April 19, 1999

RE: SJRPP PPSA Site Certification No. PA-81-13
Postcertification Amendment to Site Certification Application
Regarding Materials Handling Operations

FIGURE 2.1-7 (BLOUNT ISLAND MATERIALS HANDLING FACILITIES)

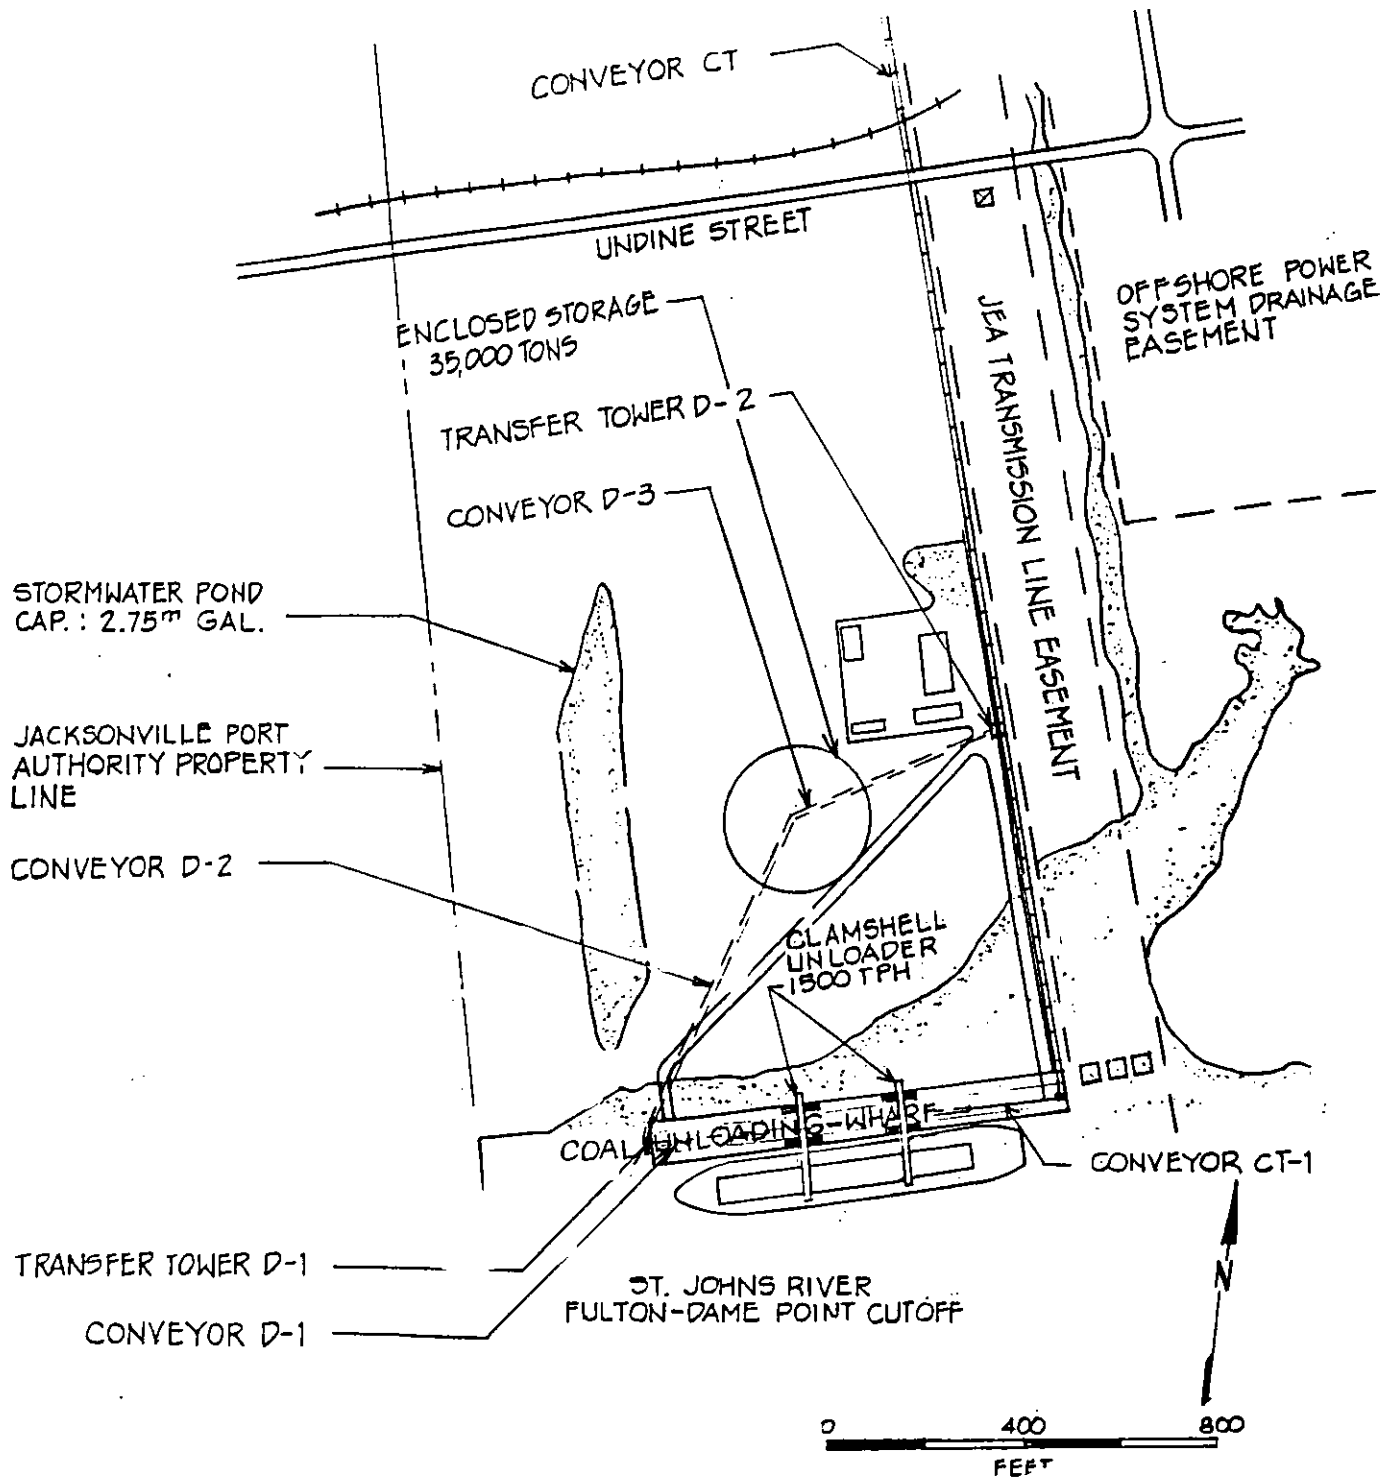
The proposed site layout for the ~~coal~~ materials handling facility on Blount Island is shown in Figure 2.1-7. Major facilities at the site are the ocean vessel ~~coal~~ unloading wharf, ~~the stacker-reclaimer and coal storage pile, the railcar loading area, emergency coal stackout and the runoff holding basin~~ two unloaders, materials surge building, main and connecting conveyors, and a stormwater pond with a capacity of 2.75 million gallons. Figure 2.1-8 shows the surveyed MHW, referenced to the Florida State Plane Grid. The ~~coal~~ unloaders, two connecting conveyors, trestle bridge, and wharf will be the only structures on or outside MHW.

- ~~2 13~~ acres for ~~coal storage~~ materials surge building
- 4 acres for ~~holding basin~~ stormwater pond
- ~~2 3~~ acres for the ocean vessel ~~coal~~ unloading wharf
- 1 acre for ~~the railcar loading area~~ buildings
- 1 acre for conveyors
- 2 acres undisturbed salt marsh
- ~~2 1~~ acres for ~~emergency stackout~~ roads and parking lot
- ~~41 31~~ acres not presently designated for use or protection
- 55 acres total

Figure 3.1-1a Material Handling Layout

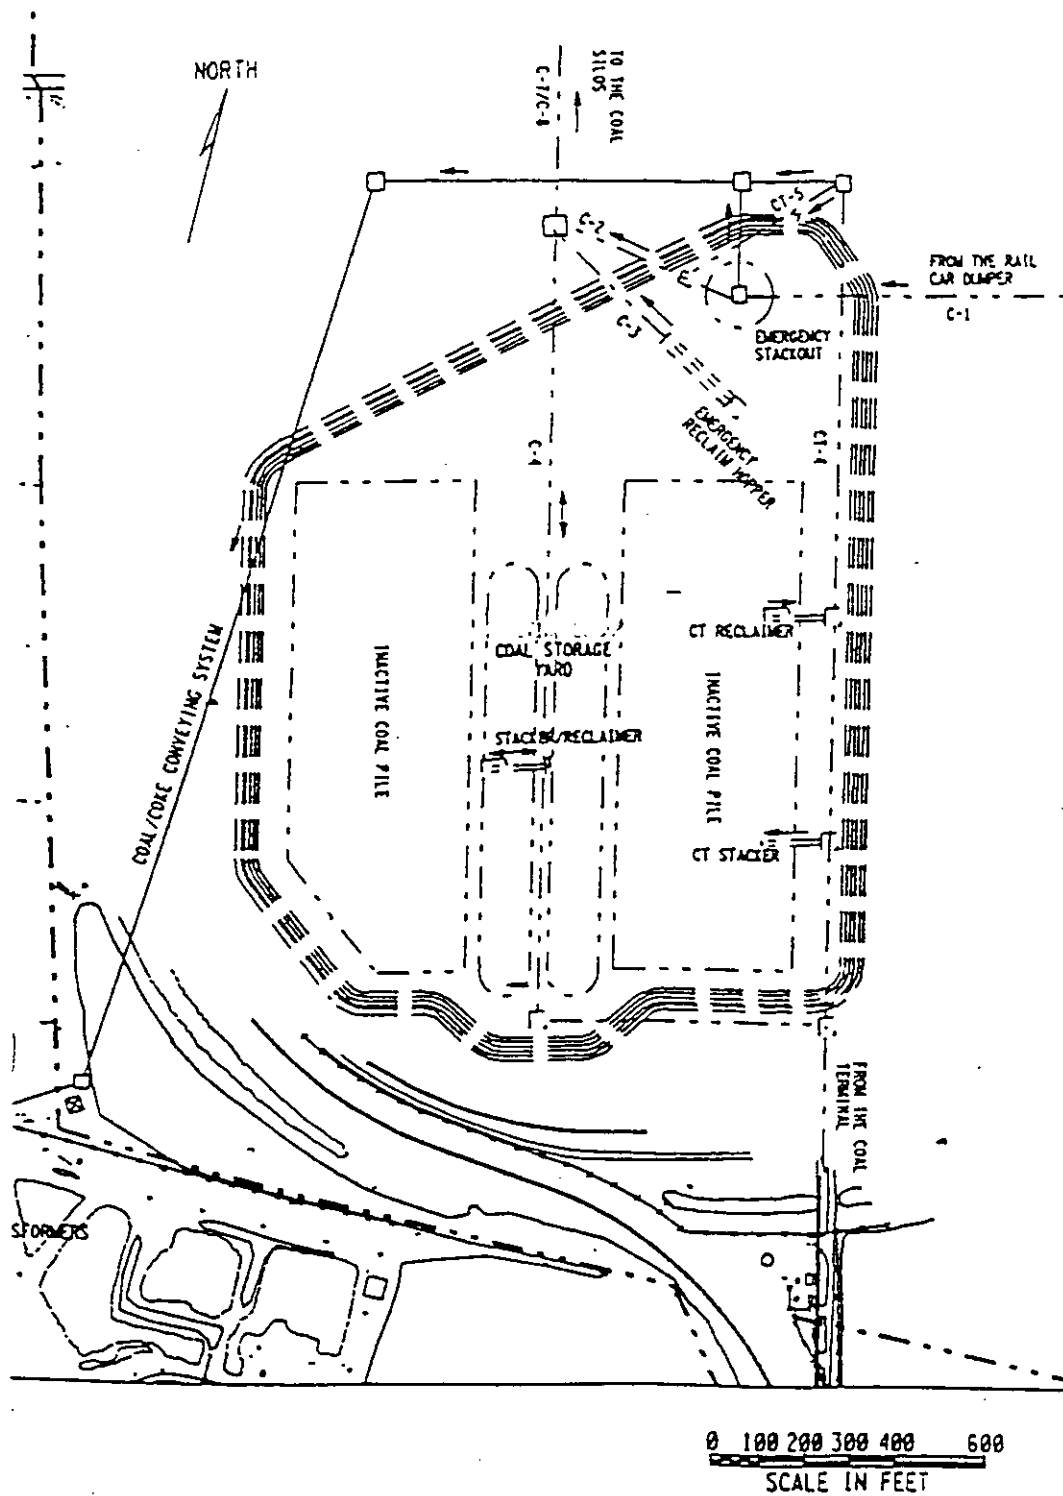
With the Northside Repowering, JEA is seeking authorization for two alternatives for the delivery of materials (coal, petroleum coke, and/or limestone) to NGS. The "Base Case" relies primarily on a new ship unloading facility near the existing NGS fuel oil dock, with supporting capacity provided by the existing Rotary Railcar Unloader at SJRPP. The Base Case simply requires the construction of an enclosed conveyor system to transport materials from the existing materials handling area at SJRPP to the adjacent NGS. See the new SCA Figure 3.1-1a.

Figure 3.1-1b Material Handling Layout

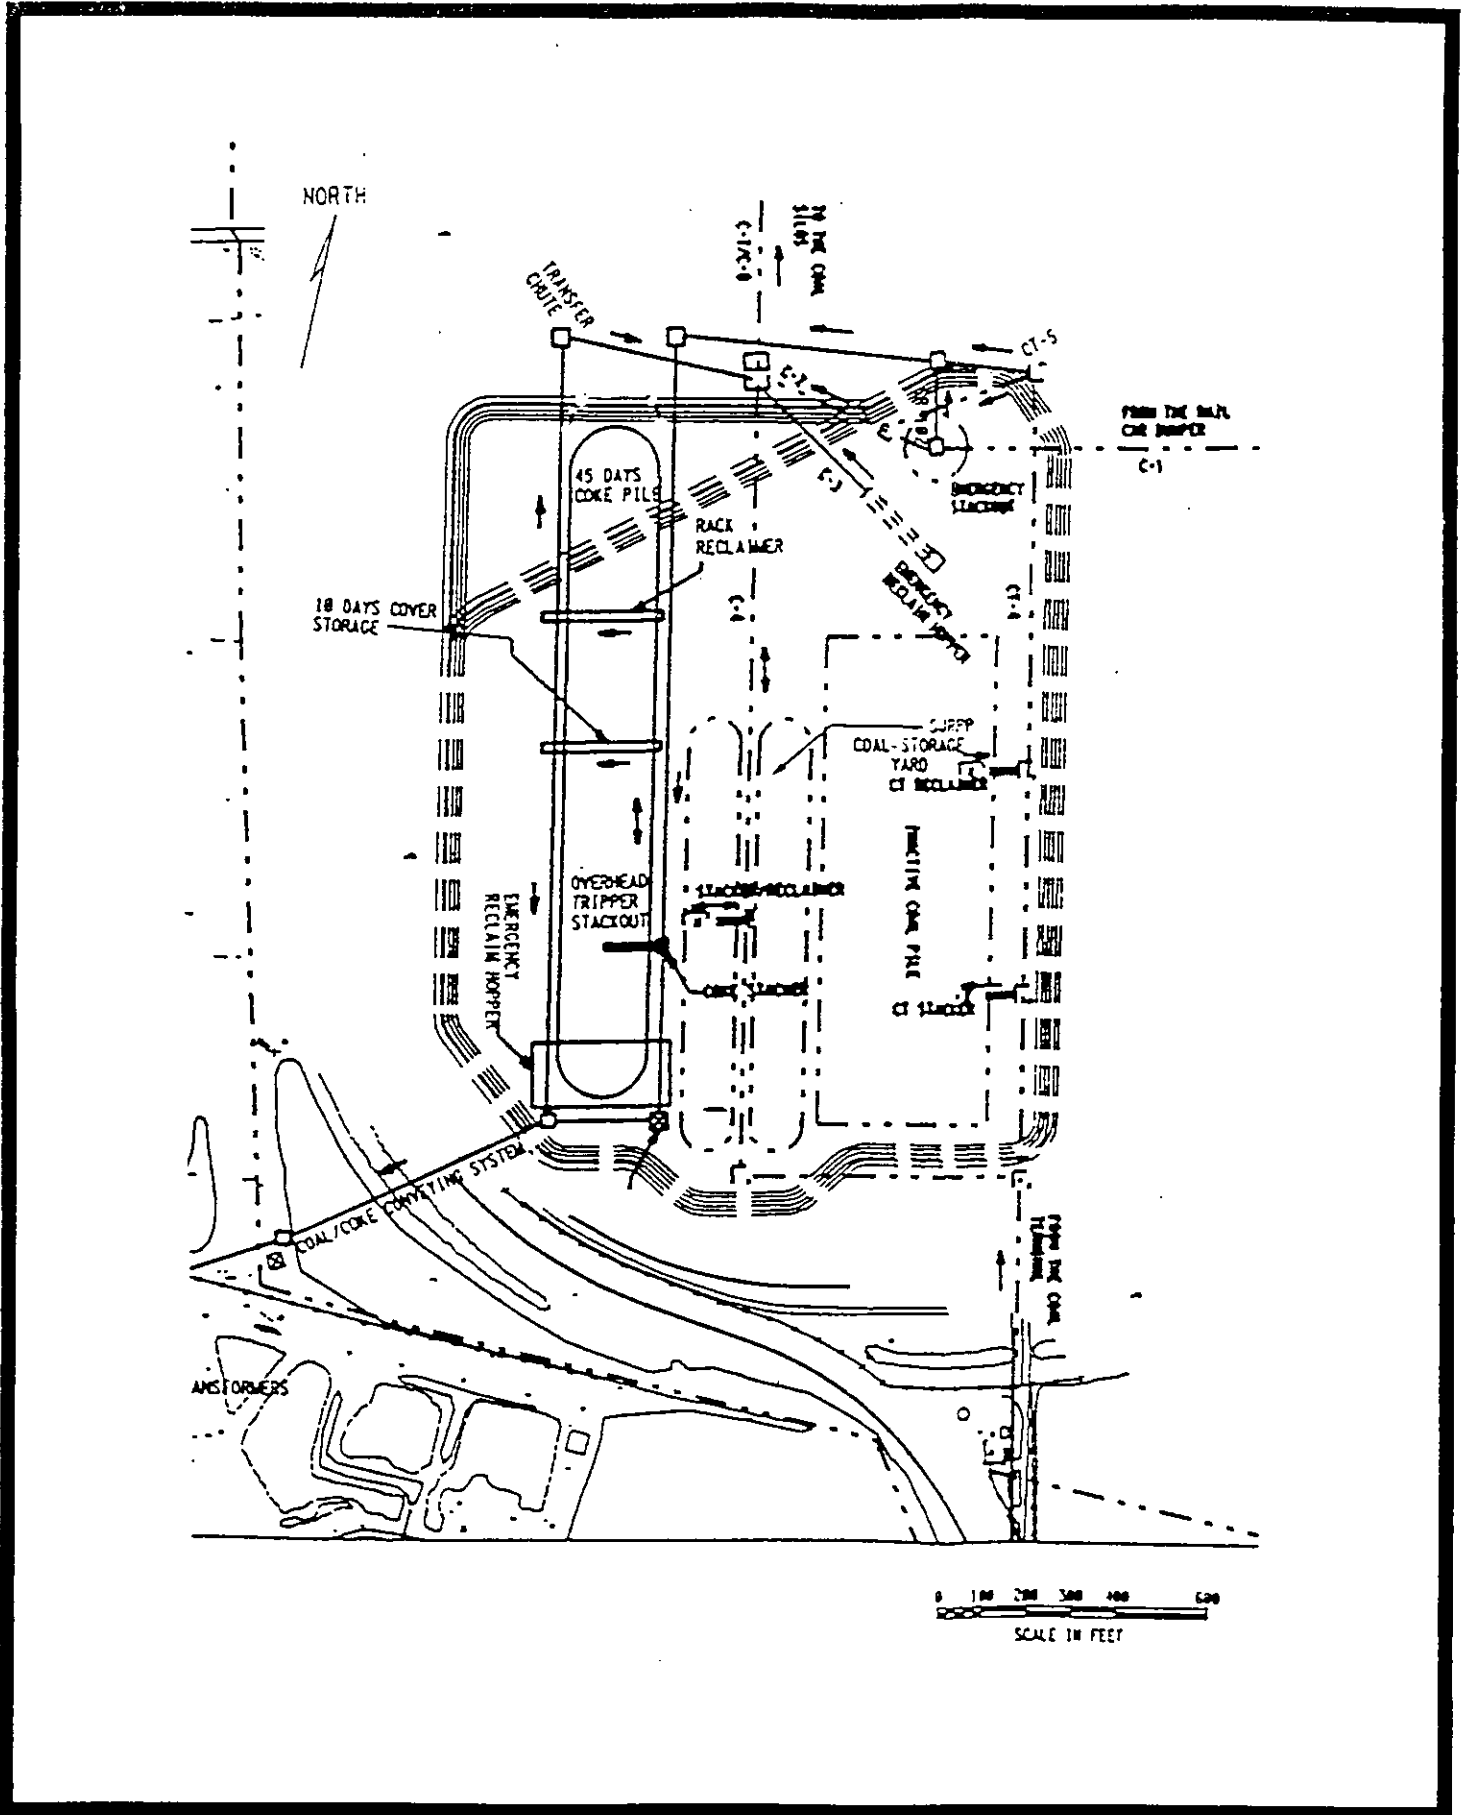
additional ship unloader at the existing St. John's River Coal Terminal wharf and new associated facilities on Blount Island: an enclosed conveyor leading off the western edge of the wharf, a new materials surge building, and an enclosed conveyor connecting this new building to the existing enclosed conveyor to SJRPP. Features comparable to each of these new facilities were contemplated and authorized during the initial Site Certification. Alternate 1 also includes a slight expansion of the SJRPP materials handling yard and the construction within it of additional materials handling facilities, such as a stacker, reclaimers, and emergency reclaim hopper. This expansion would occur completely within the existing SJRPP rail loop. As with the Base Case, Alternate 1 also requires a new enclosed conveyor system to transport materials from SJRPP to NGS. See the revised SCA Figure 3.10-2 and the new SCA Figure 3.1-1b.

FIGURE 3.10-2 (BLOUNT ISLAND MATERIALS HANDLING FACILITIES)

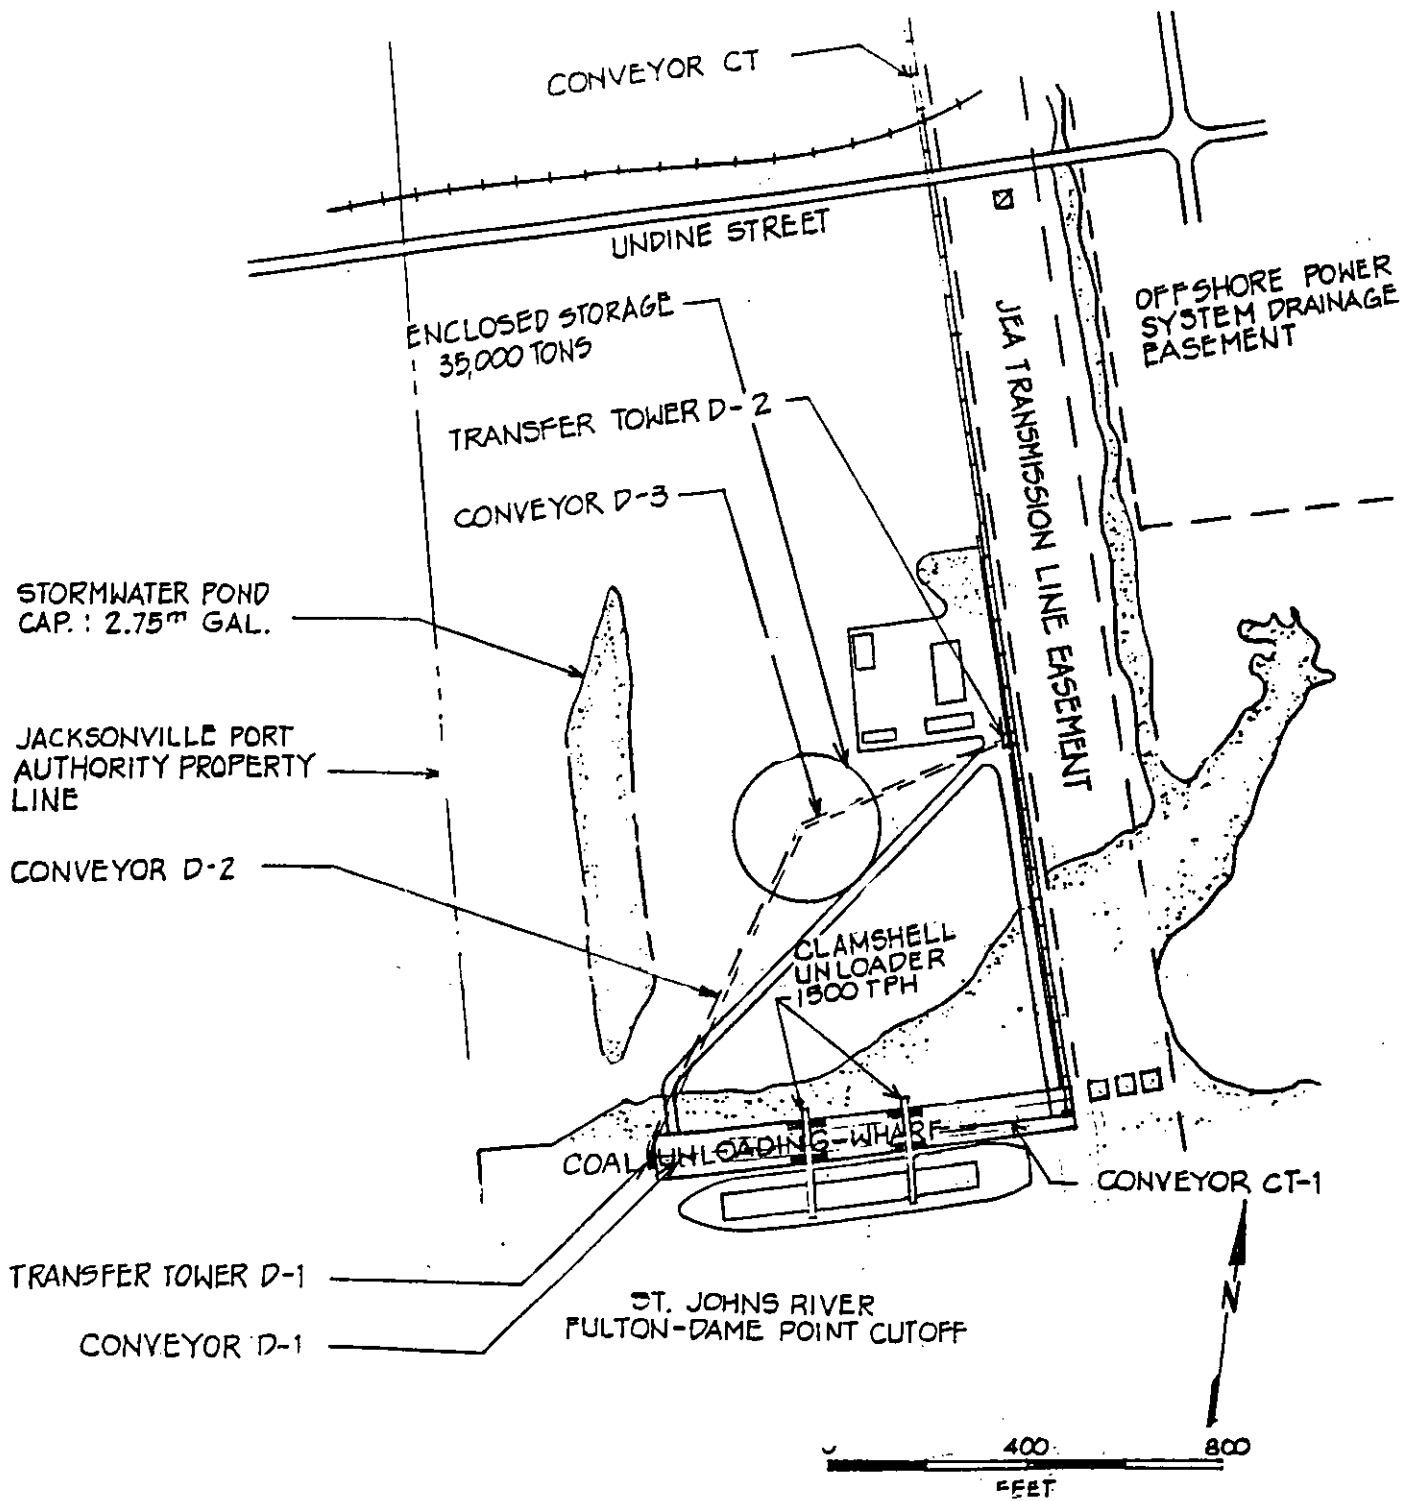
new enclosed conveyor, and the construction of the enclosed conveyor which would span from the western edge of the wharf to the uplands behind it. The new enclosed conveyor would run parallel to the existing trestle bridge, and it would be constructed in similar fashion to the existing facility. See revised SCA Figure 3.10-2.
